Revisions		
P01	22.07.16	ADDITIONAL PLANNING INFORMATION
P02	09.03.17	PLANNING AMENDMENT SUBMISSION

Client: RFU
 Project: TWICKENHAM STADIUM EAST STAND EXTENSION
 Drawing title: LEVEL 5A TERRACE ELEVATIONS

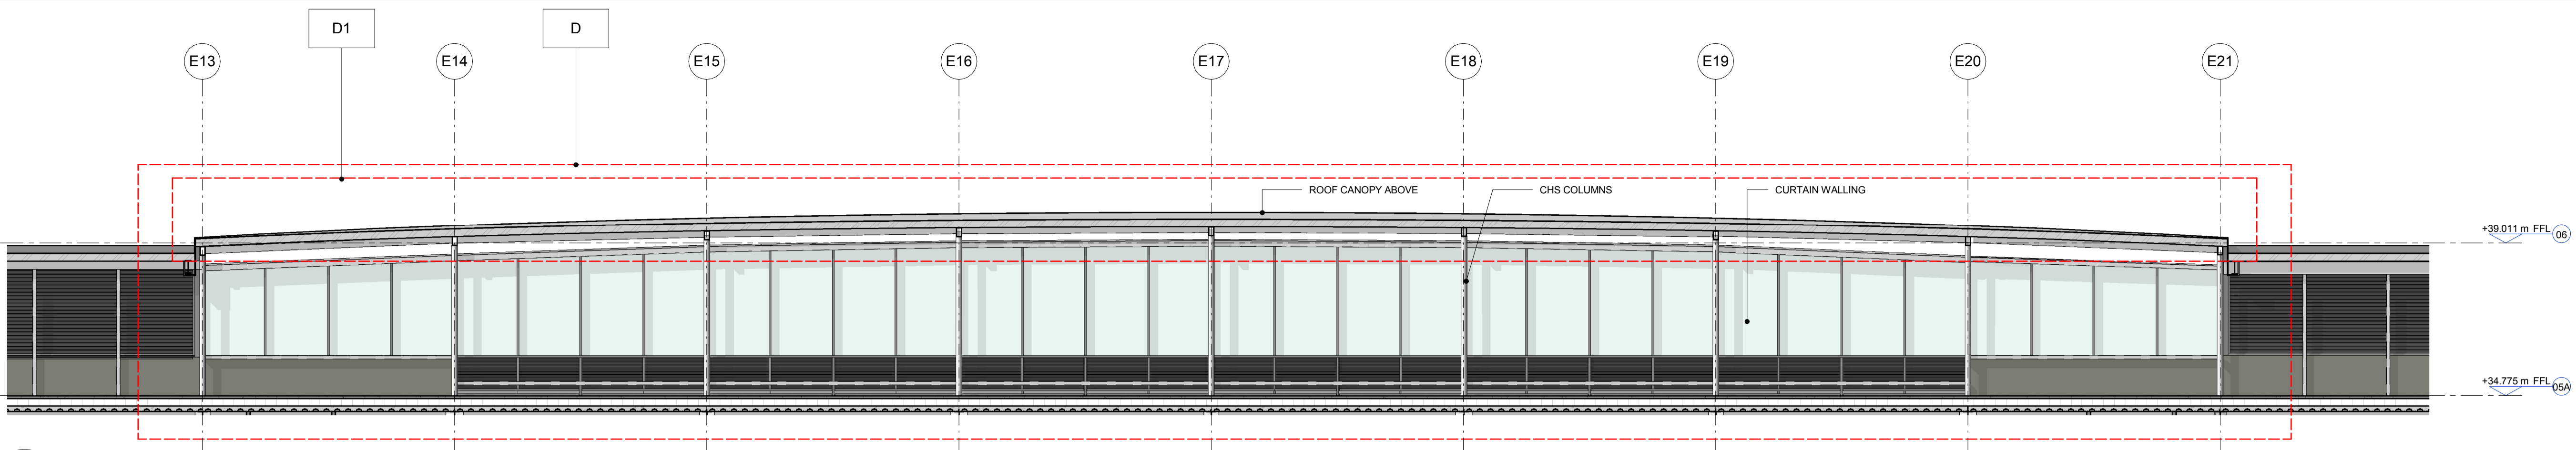
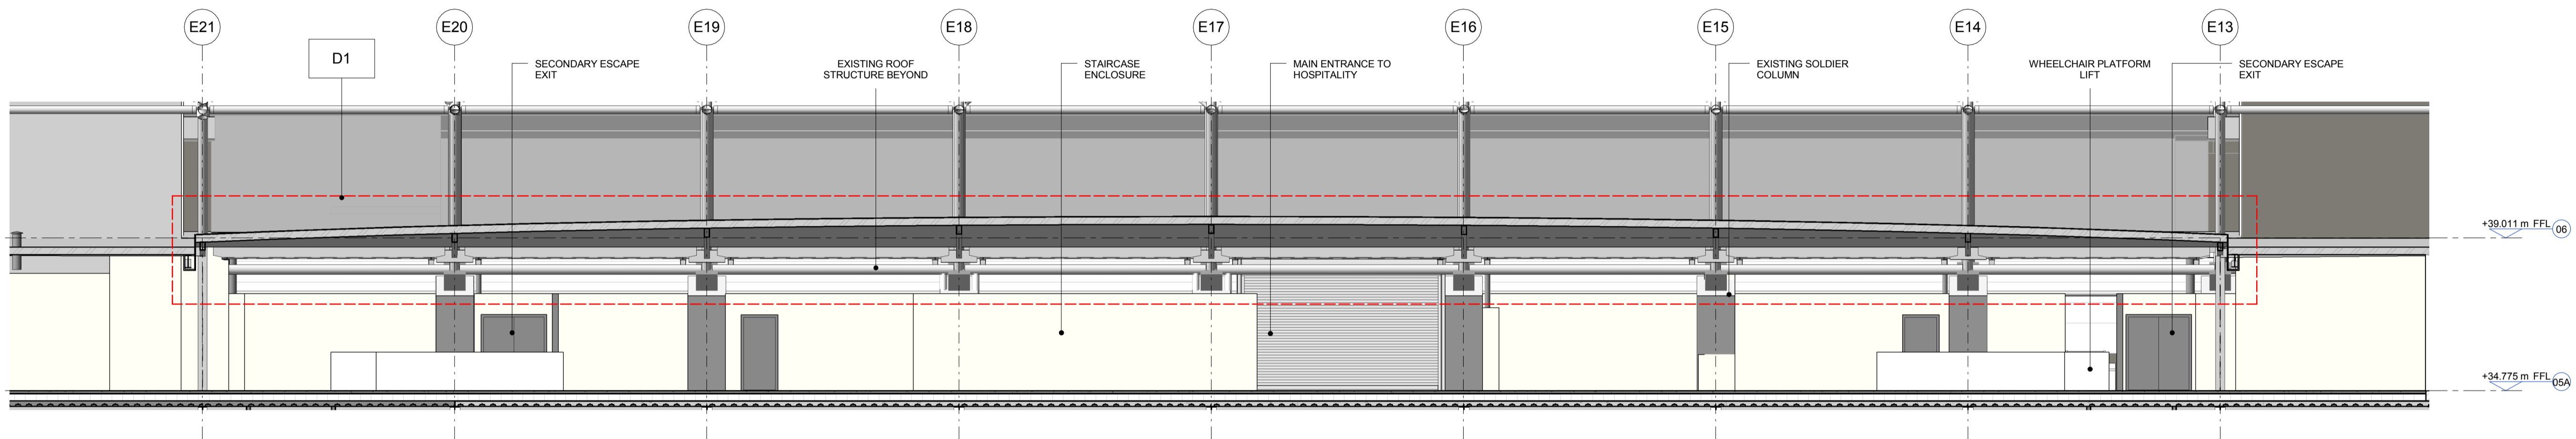
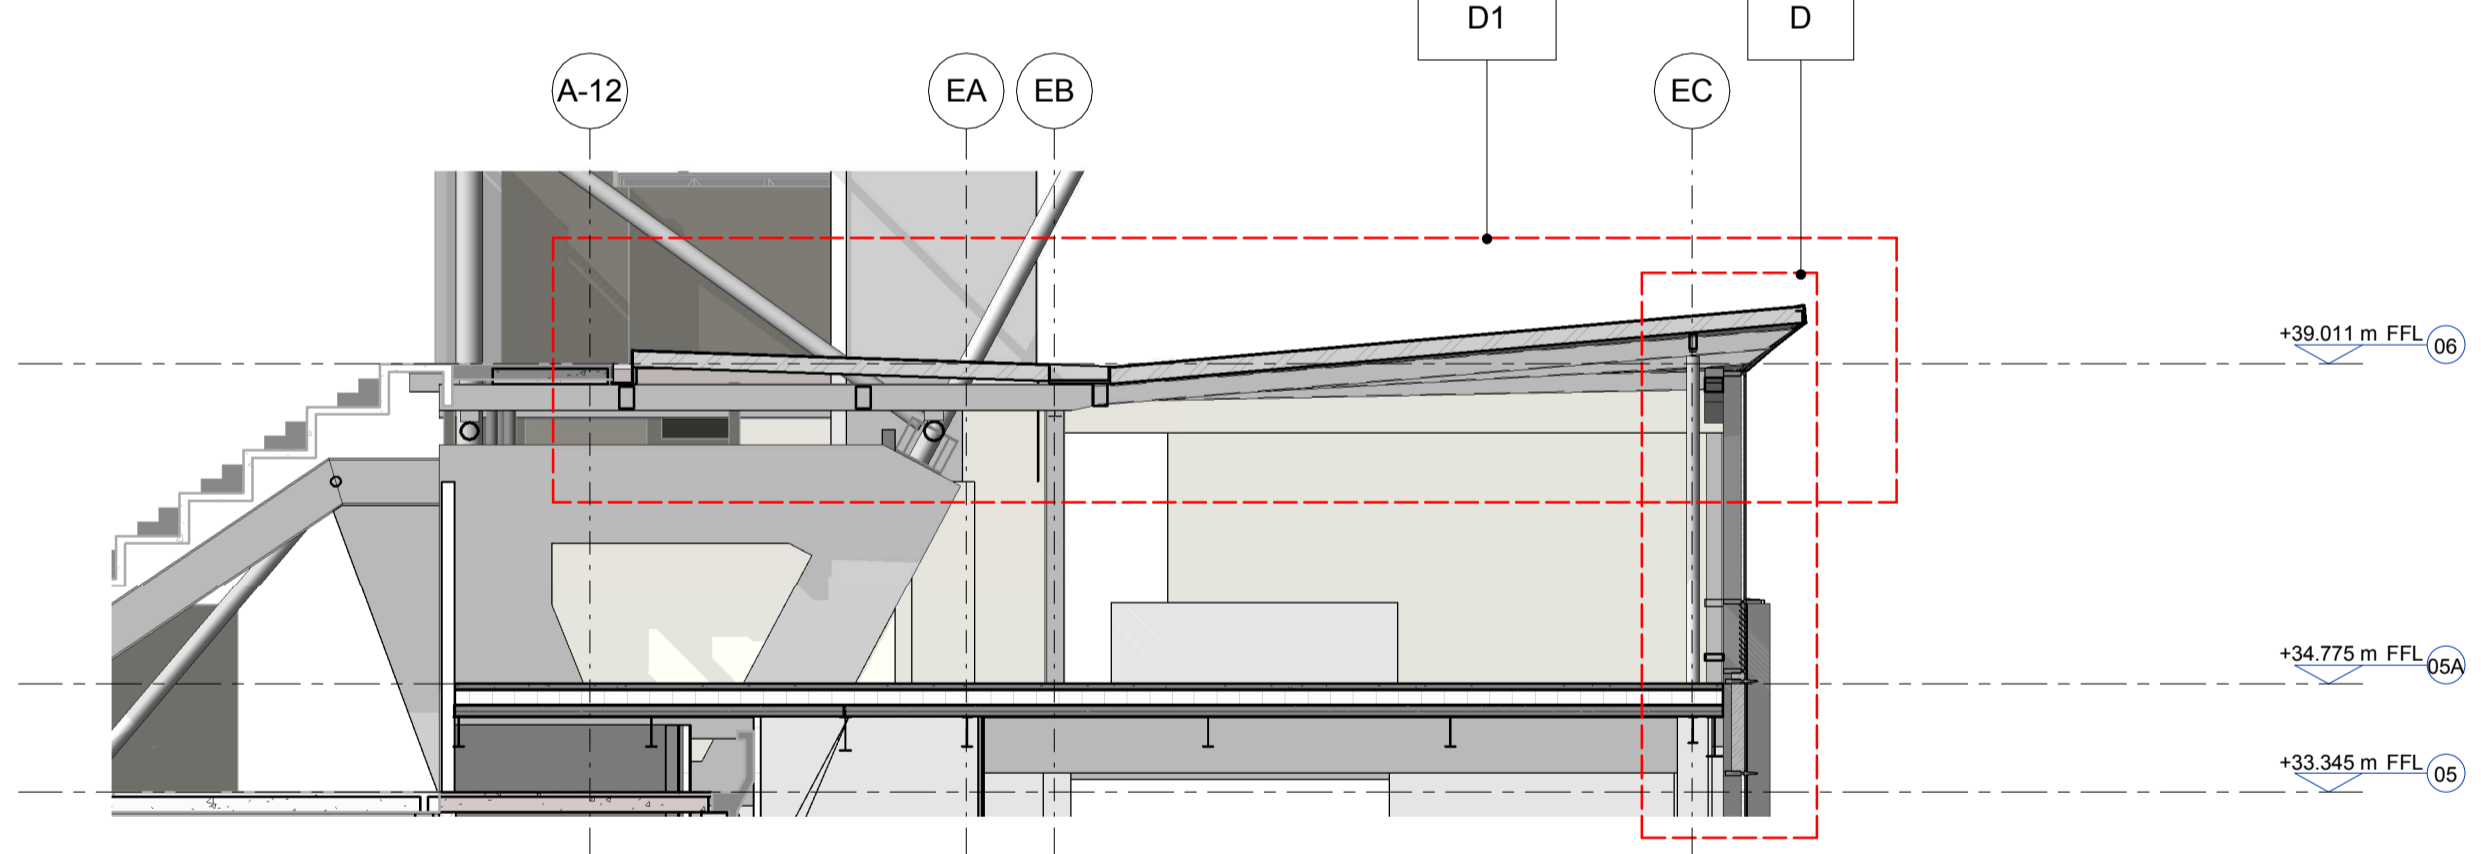
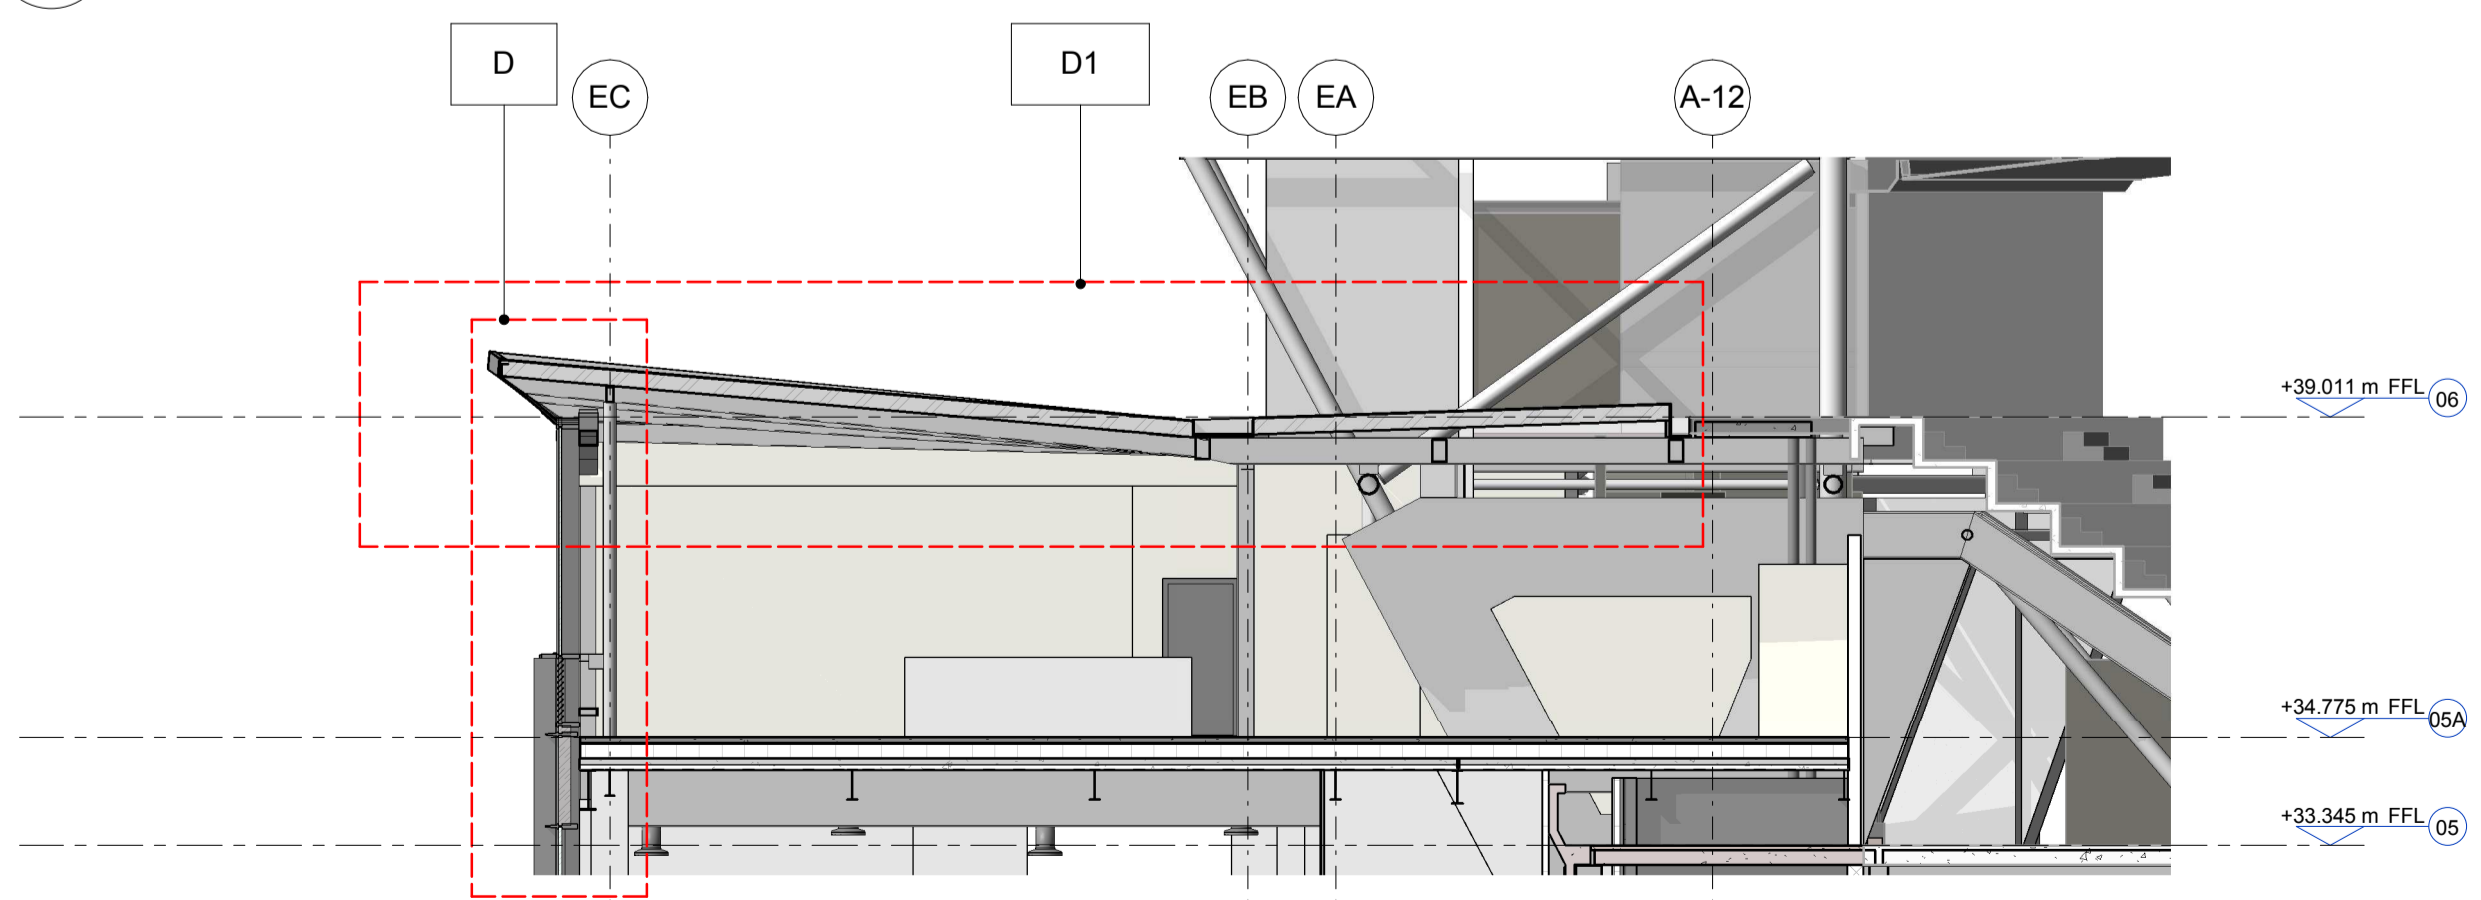
PLANNING AMENDMENTS	
A	GENERAL AMENDMENTS TO THE SOUTH END. INCREASED SHINGLES CLADDING AREA AND CURTAIN WALL REDUCED ACCORDINGLY.
A2	REDUCED MASSING AND REVISED INTERFACE WITH THE SOUTH STAND.
B	PPC LOUVRES LOCATED TO THE BOWL SIDE HAVE BEEN OMITTED.
C	CURTAIN WALL SETTING OUT REVISED GENERALLY. SILICONE JOINTS TO TRANSOMS AND MULLION REPLACED WITH CAPPED SYSTEM. LEVEL 04 PPC LOUVRES SETTING OUT & HEIGHT REVISED. MONORAIL FOR ABSEILING REMOVED.
D	GENERAL AMENDMENTS TO THE CENTRAL ELEVATION CANOPY AT LEVEL 5A REVISED GENERALLY AND STANDING SEAM REPLACED WITH SINGLE PLY MEMBRANE. SUPPORT COLUMNS TO ROOF CANOPY REVISED. SQUARE FASCIA TO ROOF EDGE.
D1	LEVEL 5A GLAZED SCREEN EXTENDED IN HEIGHT AND PPC LOUVRES INCLUDED AT LOW LEVEL.
D2	INCREASED SHINGLES CLADDING AREA AND CURTAIN WALL AREA REDUCED ACCORDINGLY. FOUR VERTICAL FINS REMOVED.
D3	PORCELAIN PANELS WITH SLOTTED HOLES FOR VENTILATION REPLACED WITH PPC LOUVRES. EXPRESSED HORIZONTAL PATTERN TO PORCELAIN PANELS OMITTED.

E	GENERAL AMENDMENTS TO THE NORTH END PORCELAIN CLADDING REPLACED WITH PPC ALUMINIUM CLADDING.
E1	GREEN WALL TO THE NORTH END EXTENDED AND PPC LOUVRES REMOVED.
E2	INCREASED SHINGLES CLADDING AREA AND CURTAIN WALL REDUCED ACCORDINGLY.
F	FENCELINE, GATE AND PERIMETER COLUMNS SETTING OUT REVISED.
F1	CANOPY TO TURNSTILES REVISED.
G	PORCELAIN PATTERN CHANGED FROM HORIZONTAL TO VERTICAL.
H	PORCELAIN PANELS TO THE SOFFIT OF THE ARCH REPLACED WITH PPC ALUMINIUM PANELS. PORCELAIN PANELS SETTING OUT REVISED.
K	ROOF TO LEVEL 5A (NORTH END) EXTENDED.
L	GLAZED SPANDREL PANELS REPLACED WITH METAL SPANDREL PANEL. PORCELAIN PANELS REPLACED WITH PPC ALUMINIUM CLADDING.
L1	PPC LOUVRES INCLUDED FOR MECHANICAL VENTILATION.
